**TOWN OF MOUNTAIN VILLAGE
SPECIAL DESIGN REVIEW BOARD MEETING
AGENDA**

THURSDAY APRIL 22, 2021 10:00 AM

5.	10:15	30	Miller Applicant	Quasi-Judicial	Consideration of a Design Review: Final Architecture Review for a new Single-Family Detached Condominium residence on Lot 165, Unit 10, 200 Cortina Drive, pursuant to CDC section 17.4.11.

Uncompahgre Engineering, LLC

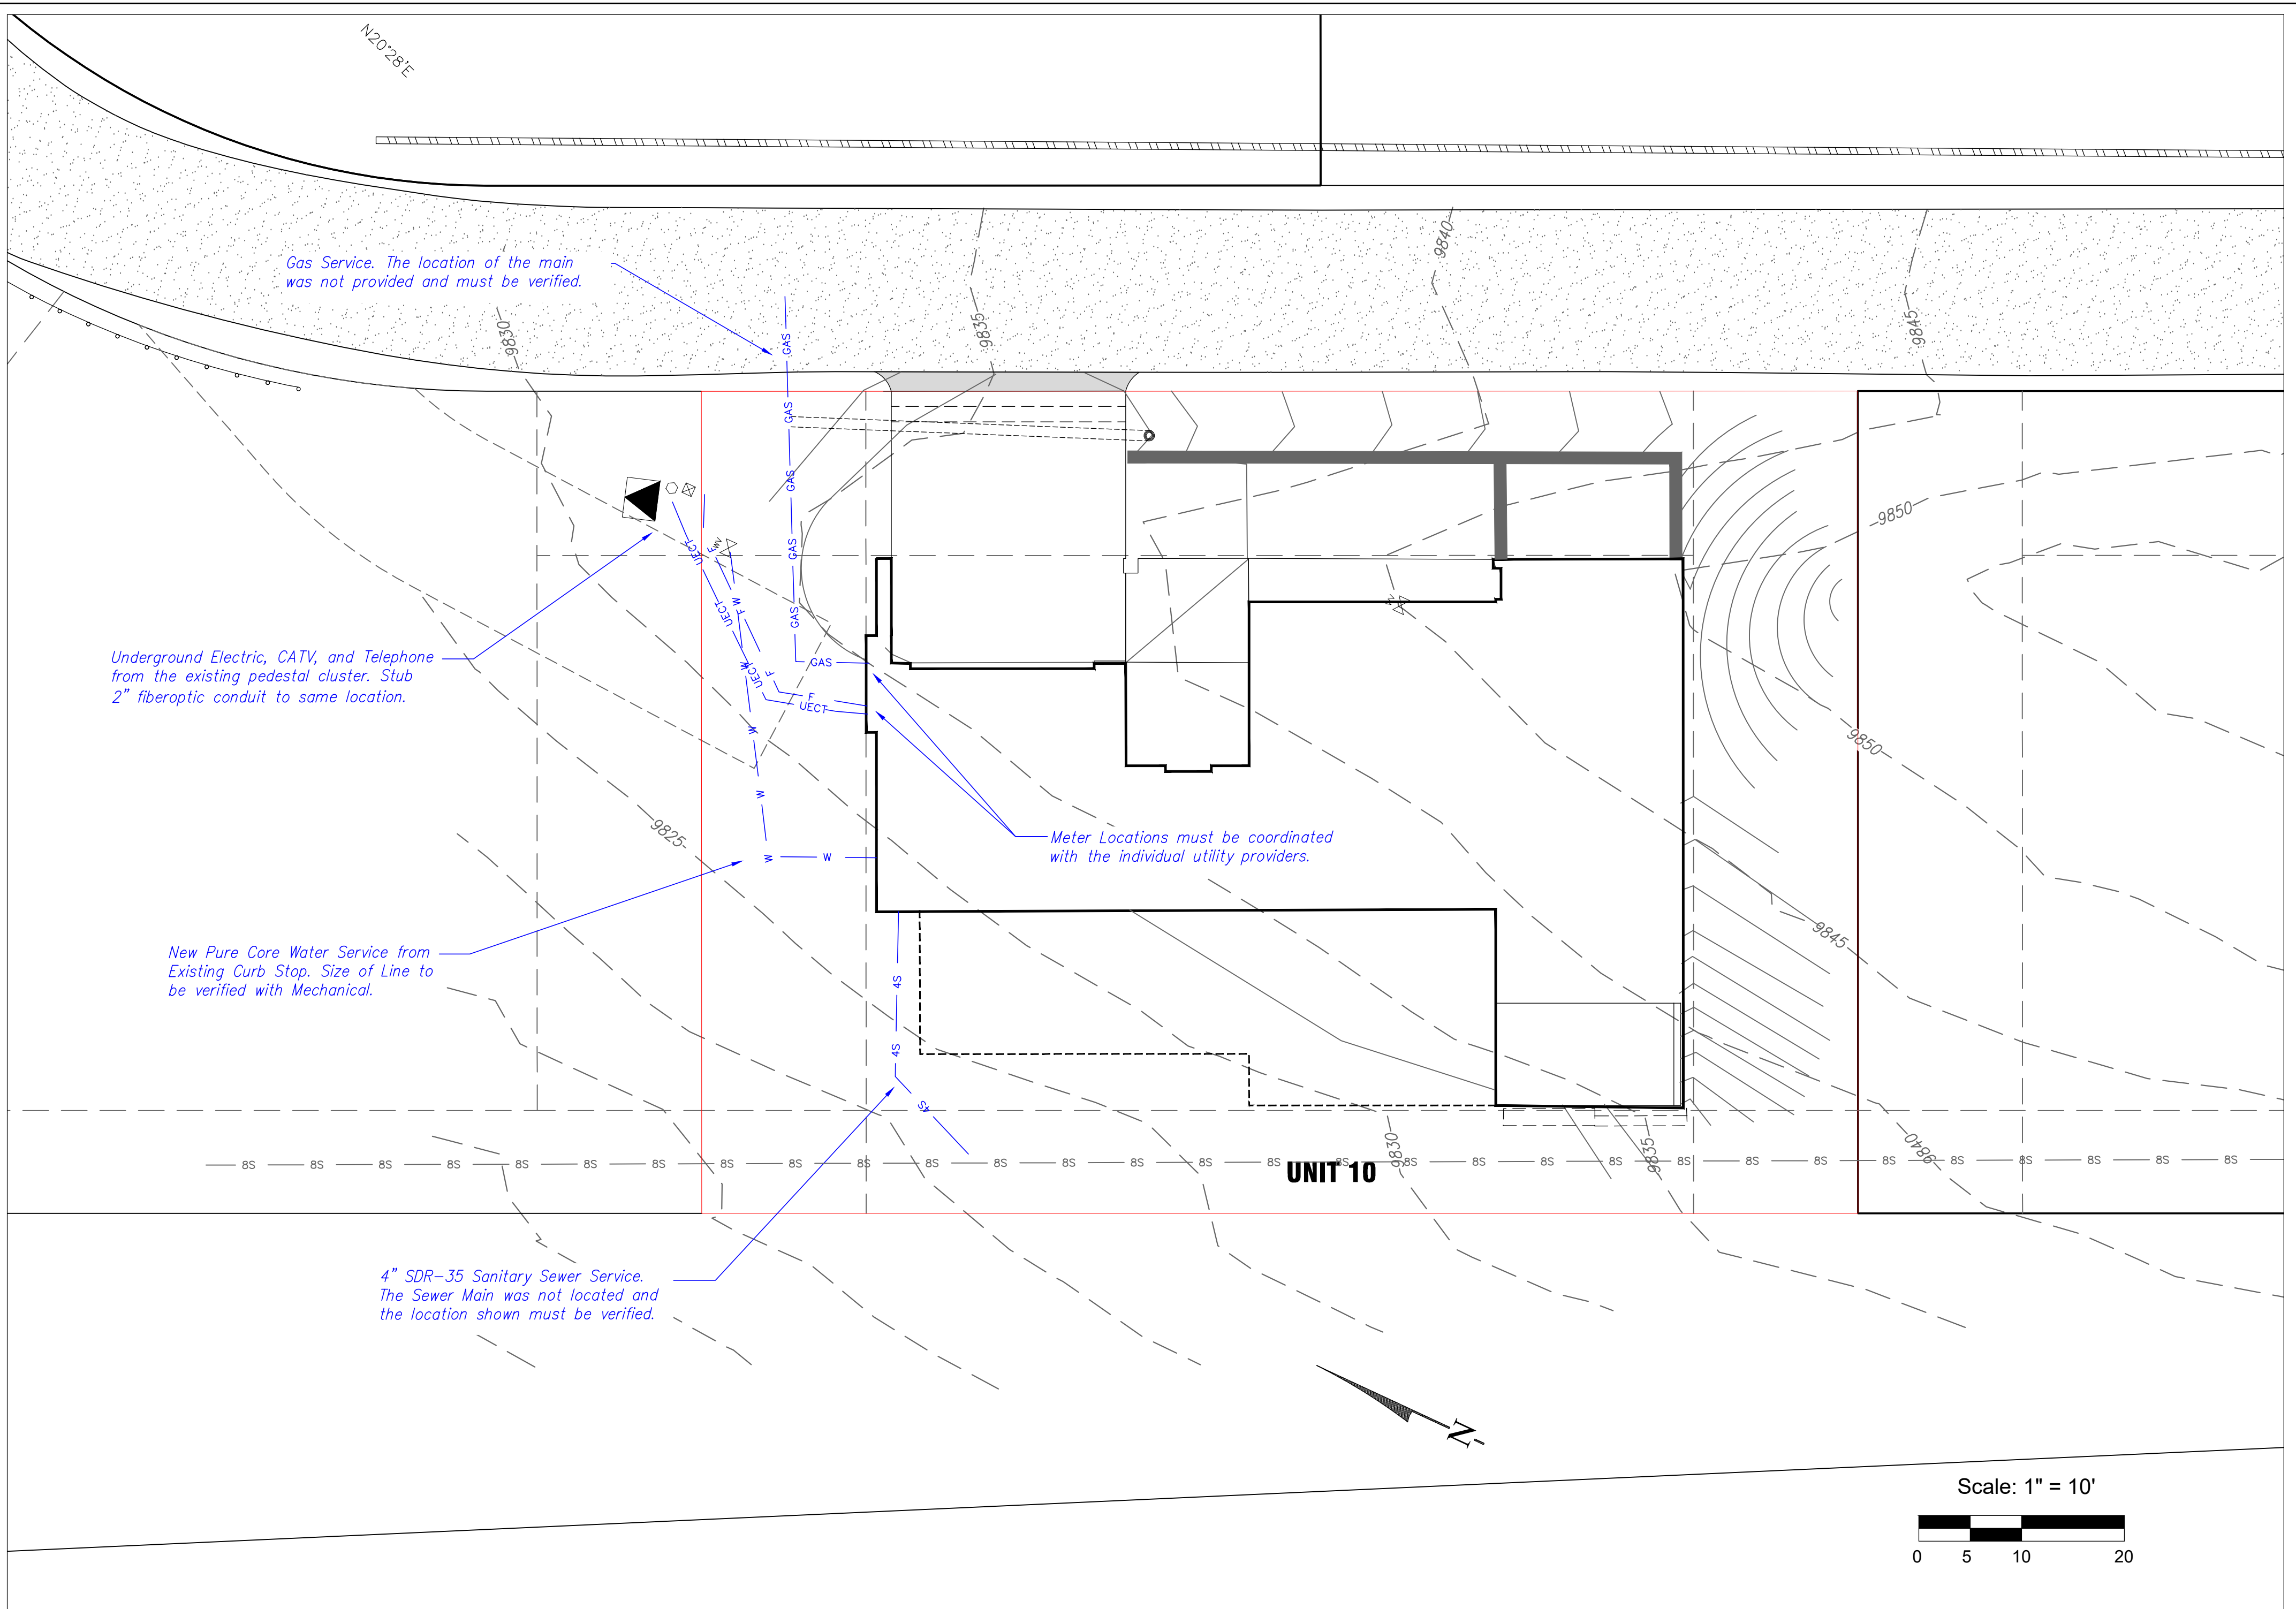
Staff: The applicant has provided a grading and drainage plan provided by Uncompahgre Engineering. The proposal documents the grade changes required around the home, including the finished slope calculations. As required by the CDC, all disturbed areas are to have final grades of 2:1 or less. The plan also demonstrates positive drainage away from the home in accordance with CDC requirements.

1 Upper Level Exterior Lighting Plan
 Scale: 1/4" = 1'-0"

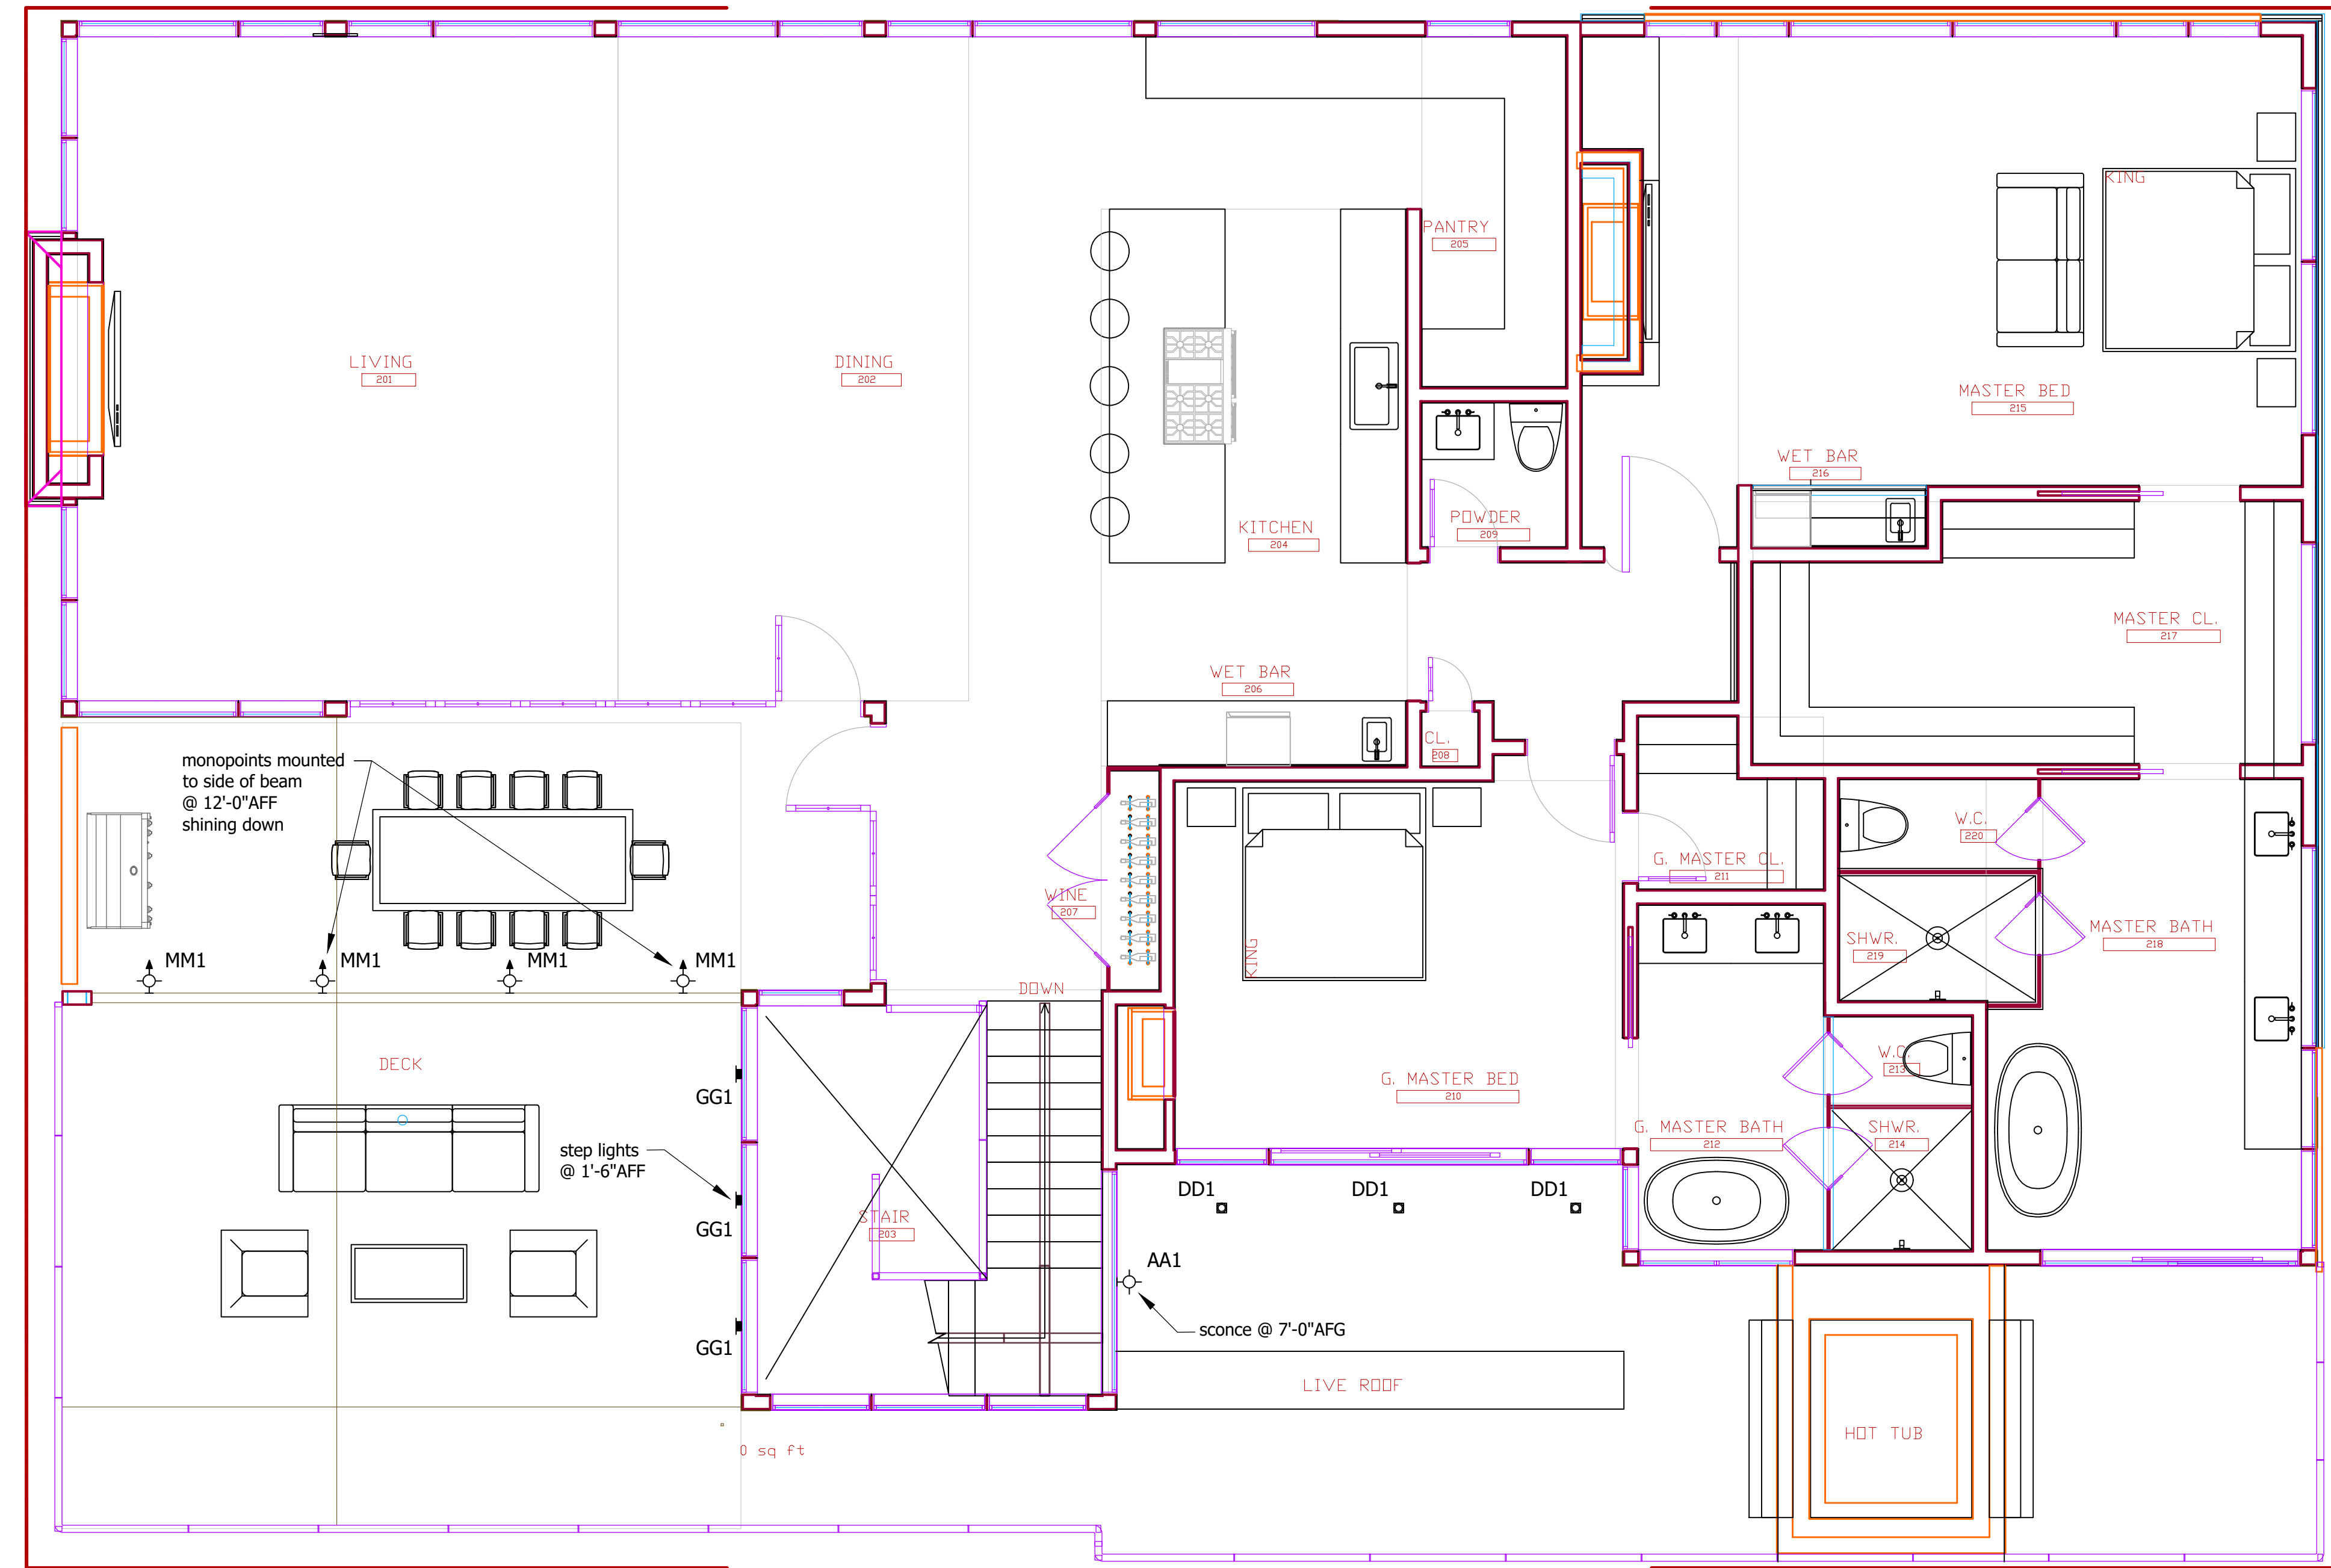
Staff: The applicant has provided an updated lighting plan demonstrating fixture type and location, photometric studies of the home, along with the cut sheets for the fixtures. Staff has the following comments based on these revisions.

- 1) Prior to the submittal for a Building Permit, the applicant shall revise the planting and irrigation schedule to meet CDC requirements – to be reviewed by staff.
- 2) Prior to the issuance of a building permit, the applicant shall provide an updated lighting plan and photometric study that shows that all exterior fixtures are in

L 1-03

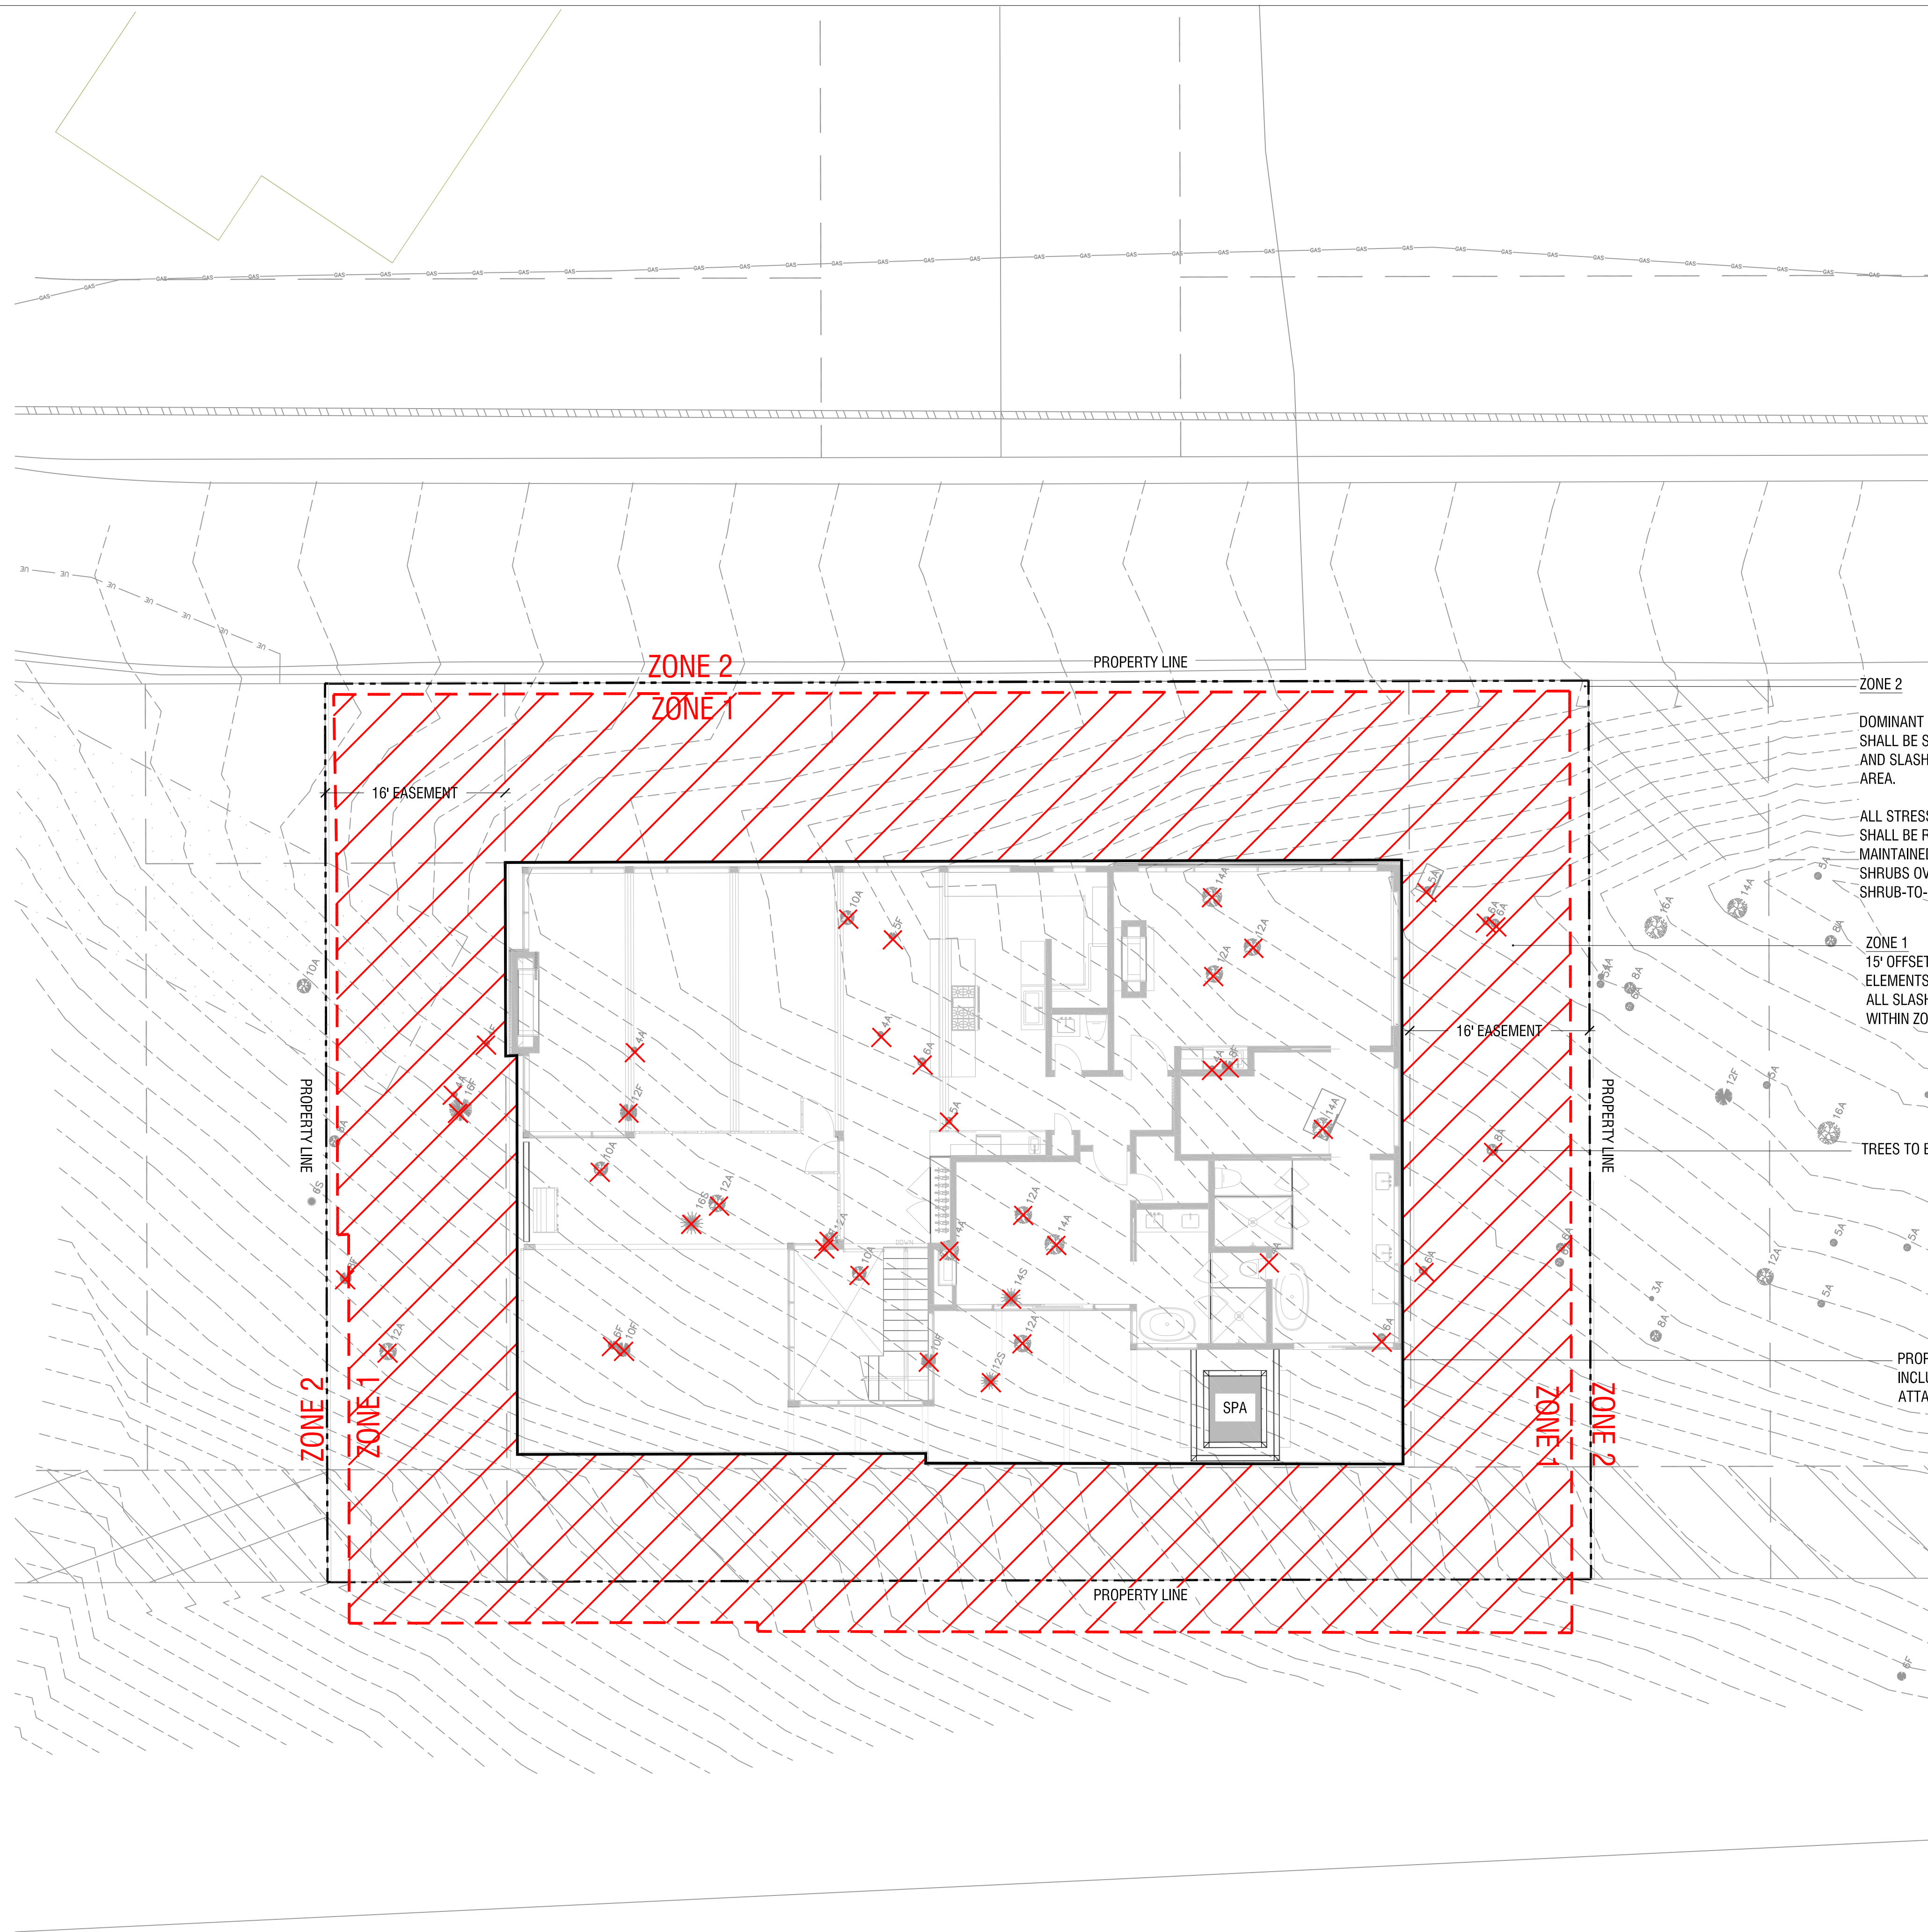
Staff: Fire Mitigation and Forestry Management: The applicant has provided some detail related to fire mitigation for Unit 10. Given the entirety of the site is located in Zone 1, almost all existing tree coverage is to be removed. Given the slopes and general
